# METROPOLITAN GOVERNMENT OF NASHVILLE AND DAVIDSON COUNTY

## STAFF RECOMMENDATION 810 Setliff Place September 17, 2014

**Application:** New construction-addition  
**District:** Eastwood Neighborhood Conservation Zoning Overlay  
**Council District:** 06  
**Map and Parcel Number:** 08306006200  
**Applicant:** Darbi Bolton  
**Project Lead:** Paul Hoffman, paul.hoffman@nashville.gov

**Description of Project:** The application is for a single-story rear addition to this contributing building.

1 Site Plan  
3/32" = 1'-0"

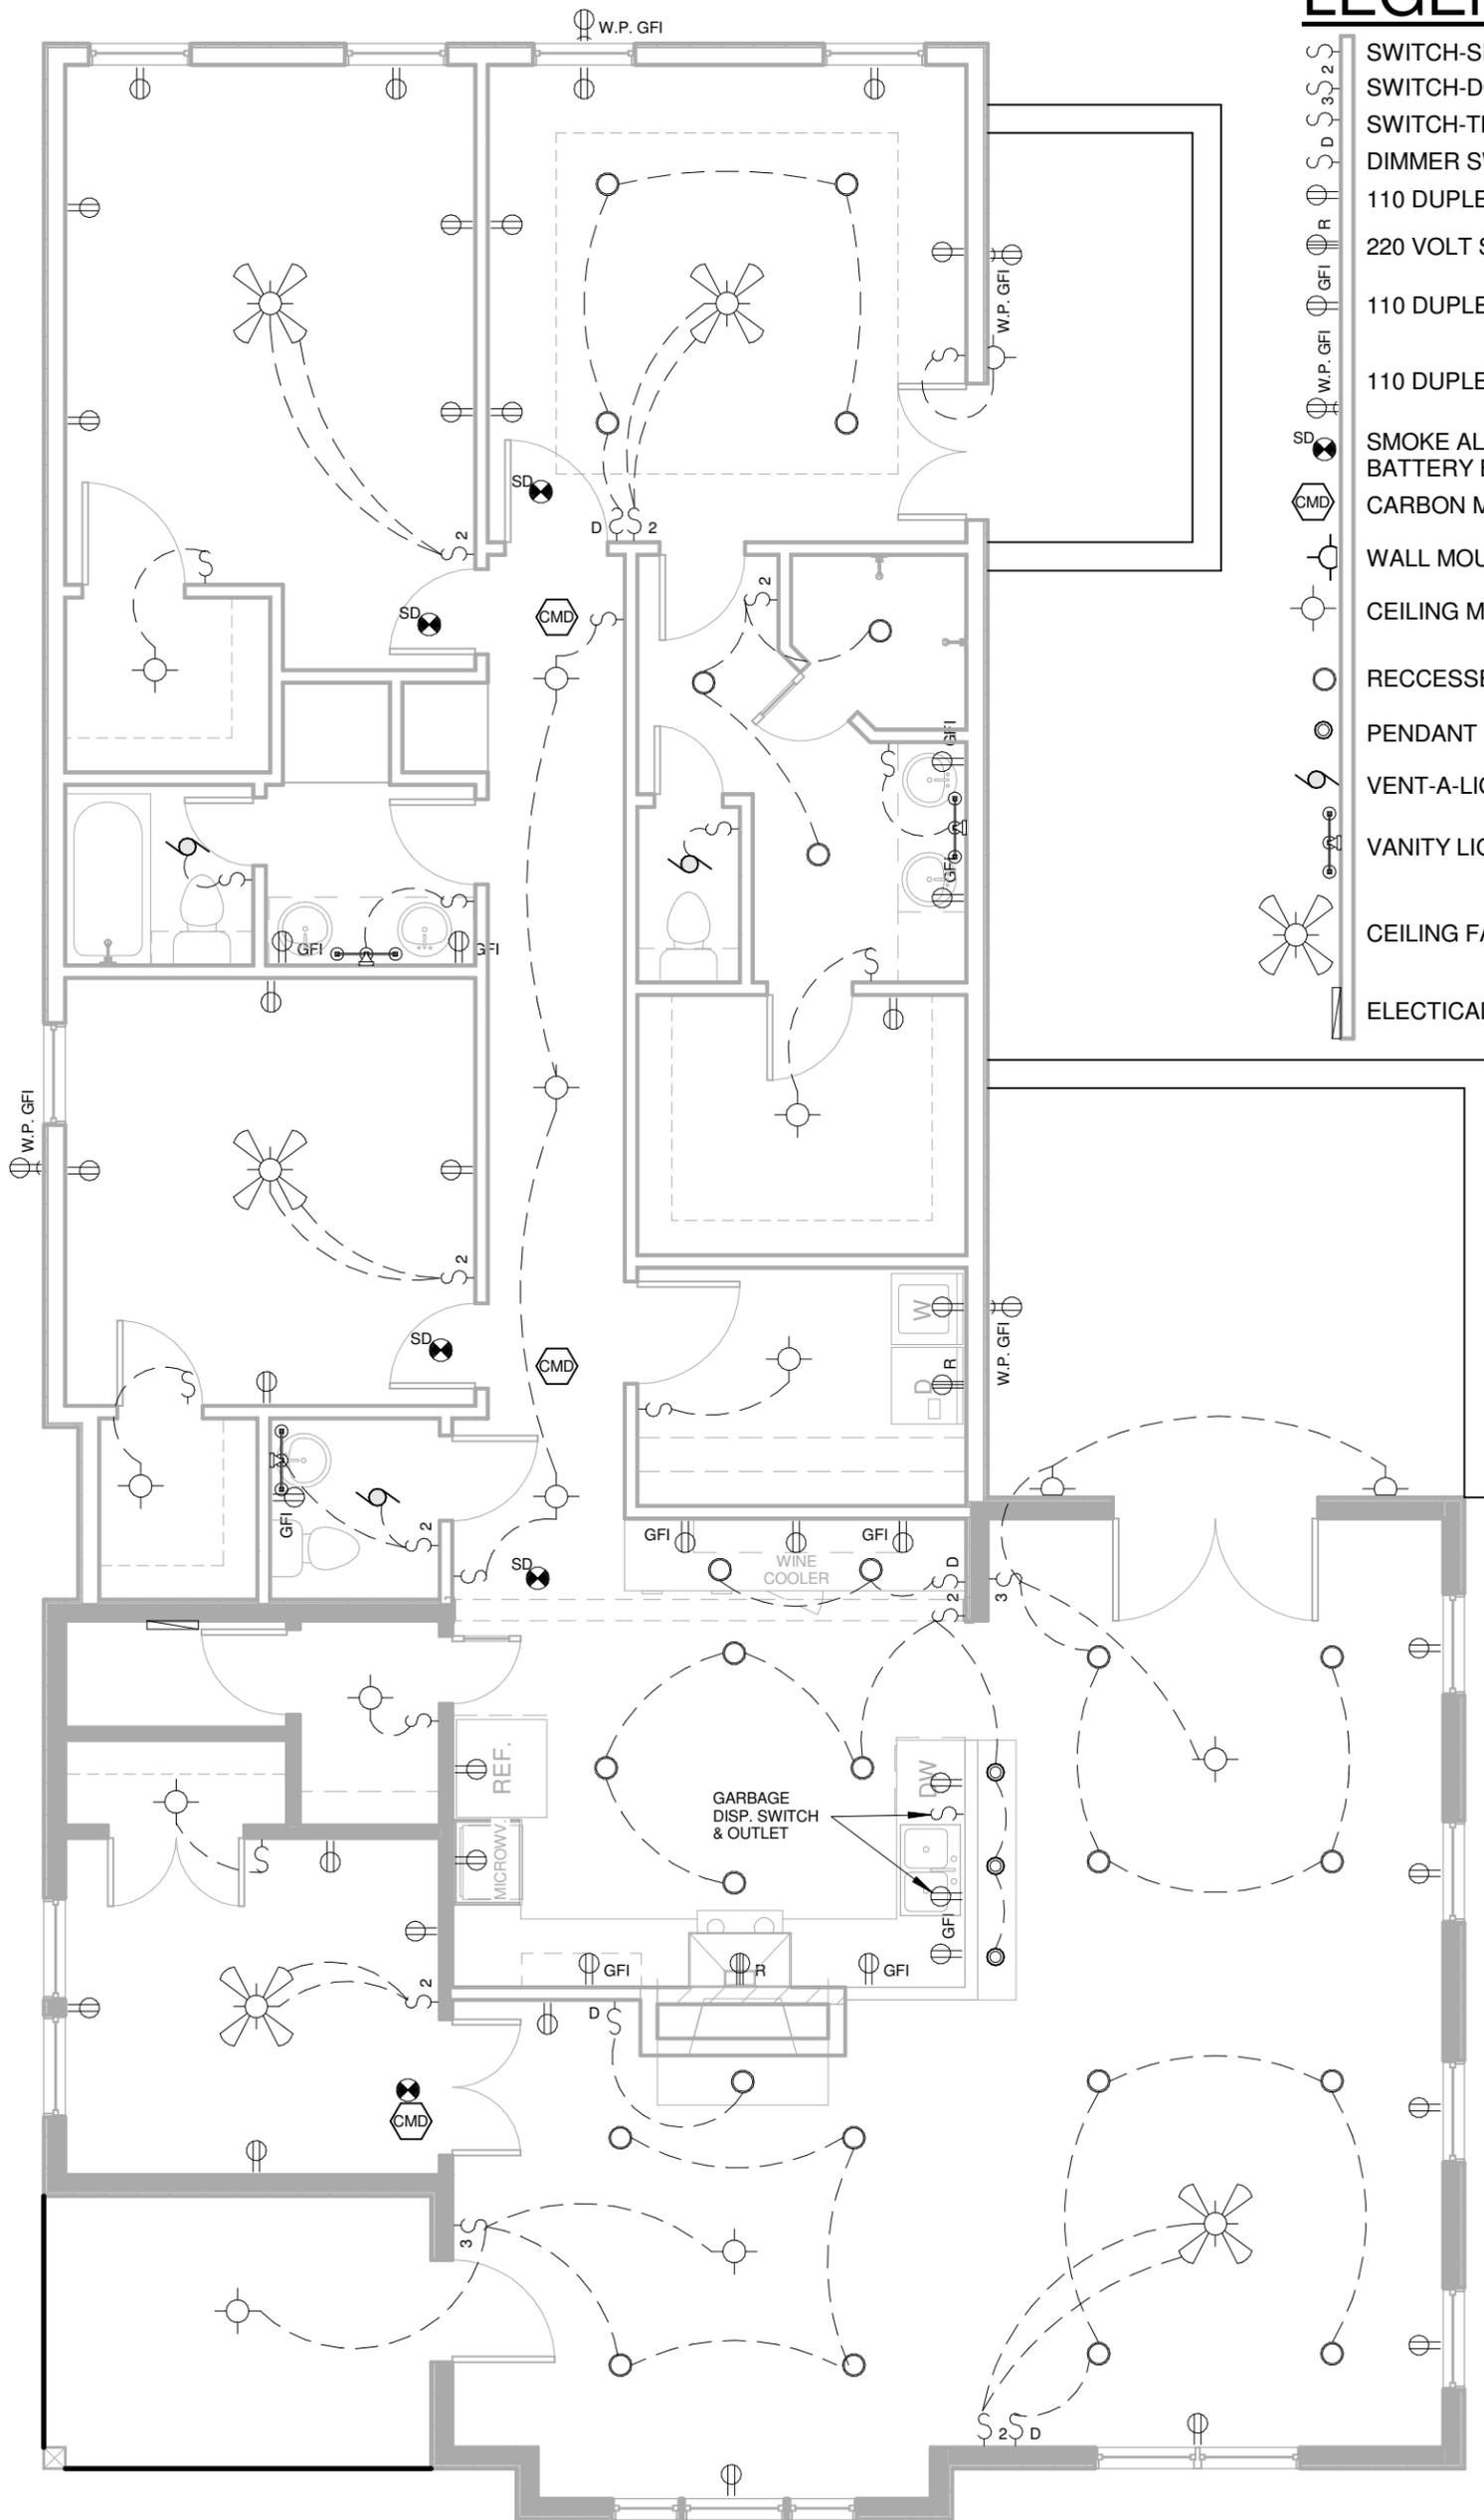
Setback & Rhythm of Spacing: The addition will not be taller or wider than the house and will have side setbacks of seven feet, six inches (7'6") and fourteen feet (14'). The rear setback will be thirty-six feet, ten inches (36'10"). The project meets base setback requirements of five feet (5') on the sides and twenty feet from the rear (20') and meets section II.B.1.c of the design guidelines.

Appurtenances & Utilities: Two wooden decks are proposed alongside the new addition. The front fourteen foot by twelve foot (14'x12') deck would encroach on the side setback as proposed. As a condition of approval, Staff recommends this deck be resized to be no closer than five feet (5') to the side property line. The location of the HVAC and other utilities was also not noted. Staff asks that the HVAC be located on the rear façade, or on a side façade beyond the midpoint of the house. With the conditions that the deck shall not encroach on the side setback, and the HVAC be located in a minimally-visible location, the project will meet section II.B.1. i.

1. Staff approve the final details, dimensions and materials of windows and doors prior to purchase and installation;
2. HVAC and other utilities shall be located to minimize visibility, if they are intended to be moved;
3. Staff approve the color of roofing material;
4. A window be added to the addition's left side to break up the large expanse of wall without an opening;
5. Lap siding shall have a reveal no greater than five inches (5"); and,
6. The 14'x12' deck shall be resized so as not to encroach on the side setback.

③ RIGHT  
 1/8" = 1'-0"

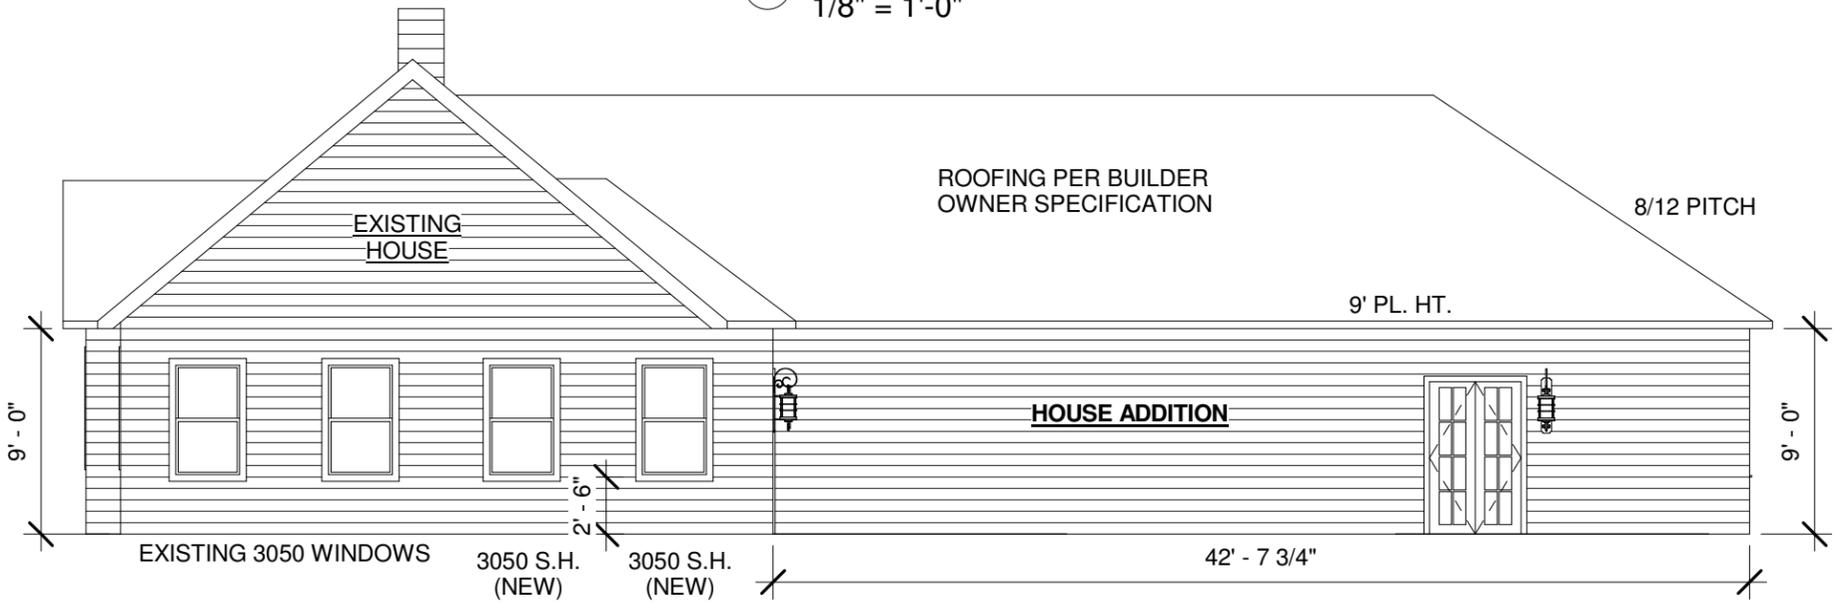
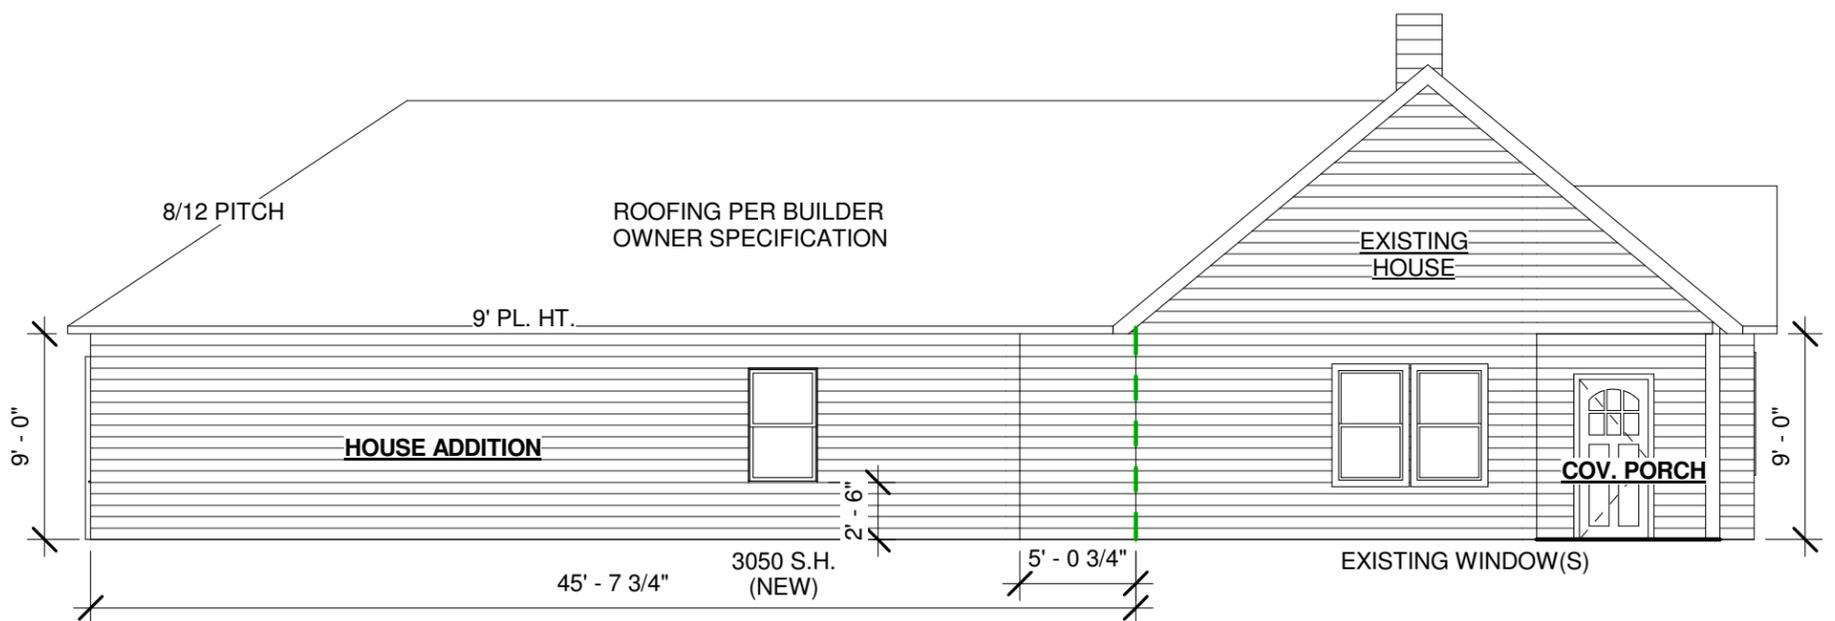
Proportion and Rhythm of Openings: The fenestration of the existing house is proposed to be altered at the rear right side, where an existing window would be replaced by two windows. As this is at the rear of the historic building, and the neighboring home is eight feet (8') from this side of the house, the visibility of this portion of the house is minimal and staff recommends its approval.

The windows on the addition are generally twice as tall as they are wide, meeting the historic proportions of openings. There is a large expanse of twenty-eight feet (28') of wall space without a window or door opening on each side of the addition. Staff recommends at least one window be added to the left side of the addition to break up the long stretch of wall. Because the right side insets fourteen feet (14') it will not be visible and so a window is not needed on the right side. With this condition, Staff finds the project's proportion and rhythm of openings to meet Section II.B.1.g.
